Access Compliance Report

Public Rights-of-Way

Intersection ID: 3313	Main Street: PROSPERITY_CHURCH_RD	Cross Street: OLD_TIMBER_RD	Location: NW
ADA ID: C3EB5630BED1	Ramp Type: Para	Initial Pass/Fail: Fail	Overall Compliance: No
		Severity Score: 25

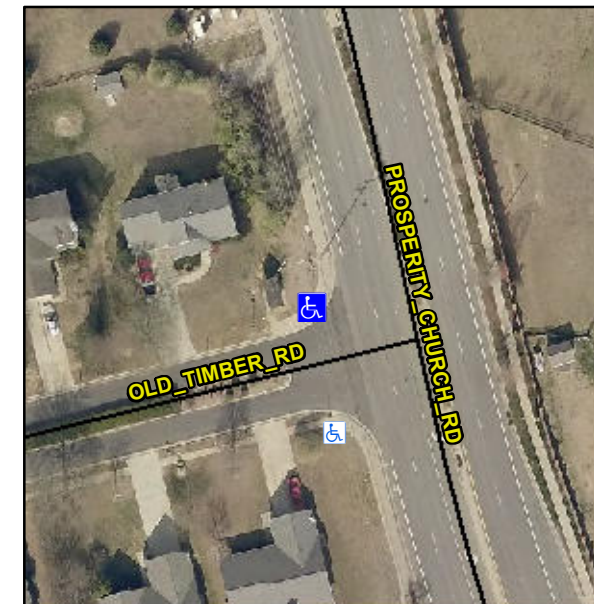
LT RP < 5%

R304.3.2

Compliance	Description	Data	Compliance	Description	Data
N/A	Ramp Length LT (in)	46.5	N/A	Ramp Length RT (in)	58.5
Yes	Ramp Width LT (in)	72.0	Yes	Ramp Width RT (in)	72.0
Yes	Ramp Slope LT (%)	3.7	No	Ramp Slope RT (%)	15.4
Yes	Ramp XSlope LT (%)	2.0	Yes	Ramp XSlope RT (%)	0.5
N/A	Landing Length (in)	N/A	N/A	DWS Provided?	N/A
N/A	Landing Width (in)	N/A	N/A	DWS Contrast?	N/A
N/A	Landing Slope (%)	N/A	N/A	DWS Length (in)	N/A
N/A	Landing X Slope (%)	N/A	N/A	DWS Full Width?	N/A
N/A	Landing Curb? (Y/N)	N/A	N/A	DWS Offset (in)	N/A
N/A	Shared Landing?	N/A			
N/A	Gutter Ponding?	N/A	N/A	Gutter Slope (%)	N/A
N/A	Gutter Lip Ht (in)	N/A	N/A	Gutter X Slope (%)	N/A
N/A	Painted X Walk1?	No	N/A	Painted X Walk2?	N/A
	X Walk 1 Direction	To S		X Walk 2 Direction	N/A
N/A	X Walk 1 Width (in)	N/A	N/A	X Walk 2 Width (in)	N/A
	X Walk 1 Slope (%)	N/A		X Walk 2 Slope (%)	N/A
	X Walk 1 X Slope (%)	N/A		X Walk 2 X Slope (%)	N/A
N/A	Ramp inside XWalk1?	N/A	N/A	Ramp inside XWalk2?	N/A

Remove & Replace Entire Ramp.
